Proposed Revisions to a Standard Plans Index

Index Number: 550-012

Index Title: BRIDGE FENCING (ENCLOSED)

LAST REVISION 11/01/17	REVISION	DESCRIPTION:		FY 2023-24 STANDARD PLANS	BRIDGE FENCING (ENCLOSED)	INDEX 550-012	SHEET 1 of 4
---------------------------	----------	--------------	--	------------------------------	---------------------------	------------------	-----------------

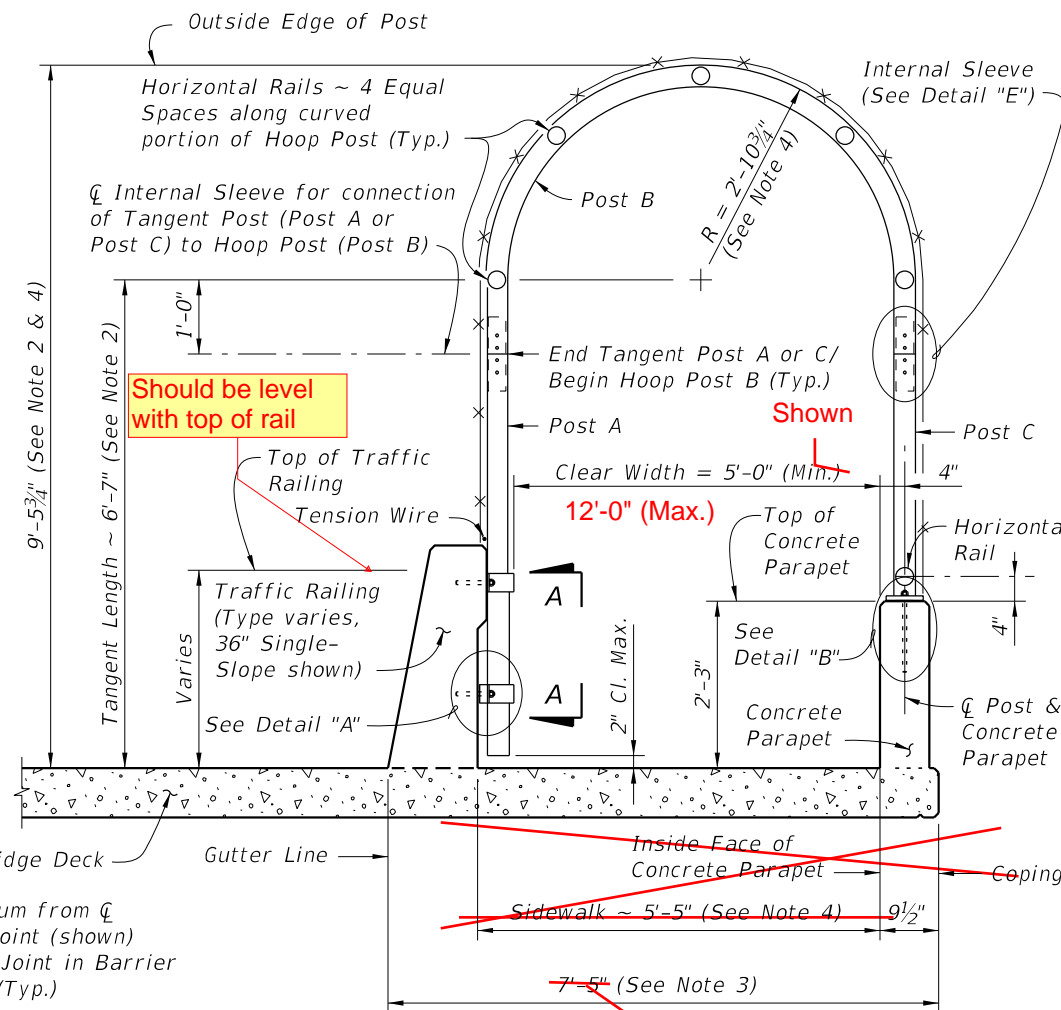
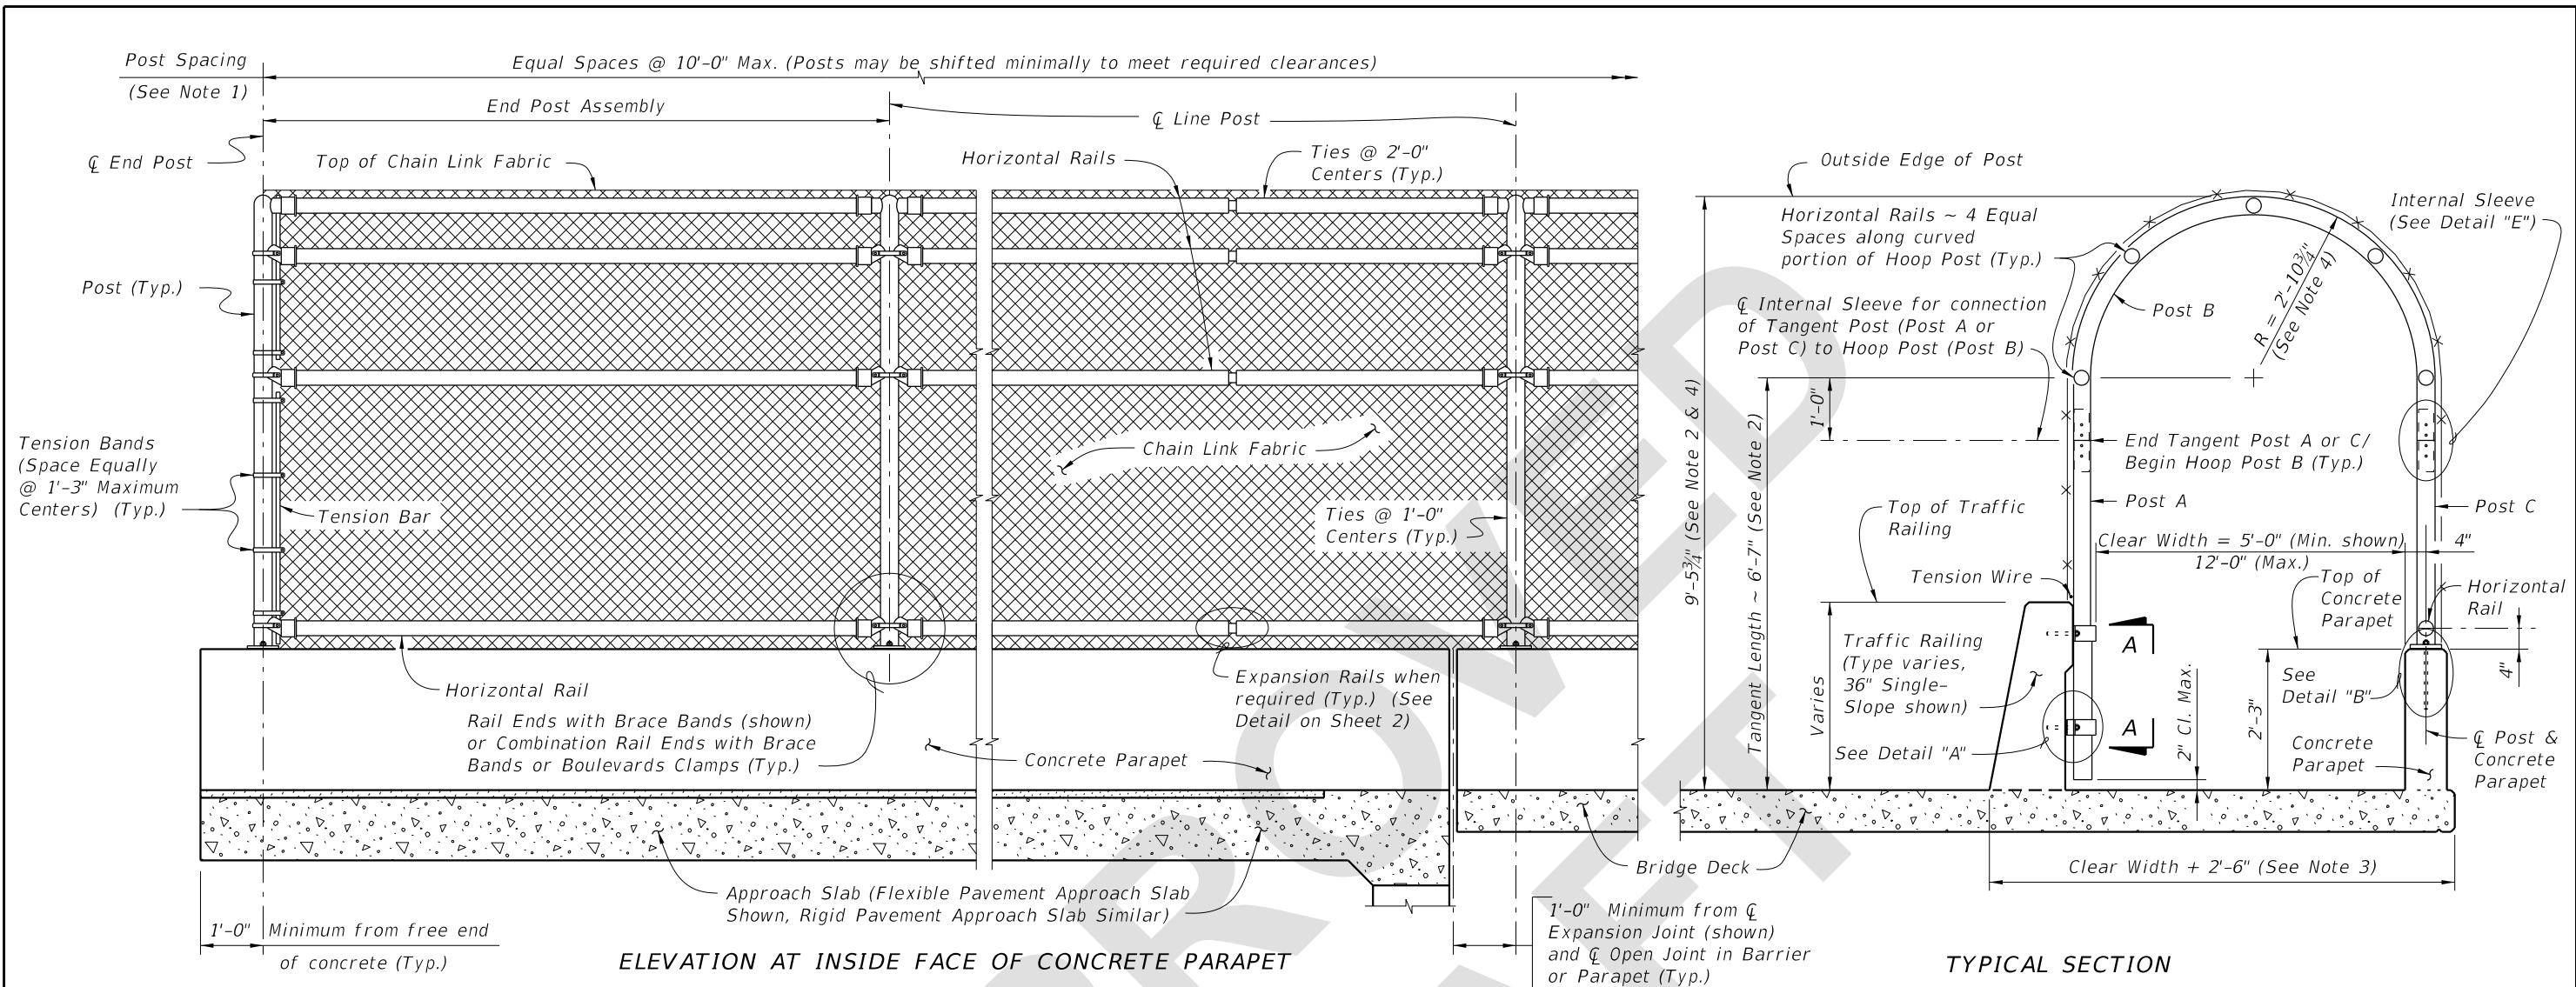
Sheet 1: Replaced the 7'-5" dimension because the calculated dimension is off by 3/8" and the dimension varies depending on clear width; Removed the 5'-5" dimension because it varies; Revised the Clear Width note from 5ft min to add 12 ft max.

An email came it that highlighted that the calculated dimensions do not match the Standard. It was determined that the dimensions were not required as they vary and recording them to the 1/8" would not be an ideal solution.

Standard allows for extension of the fencing for larger widths but those widths are not unlimited so we added a maximum of 12 ft.
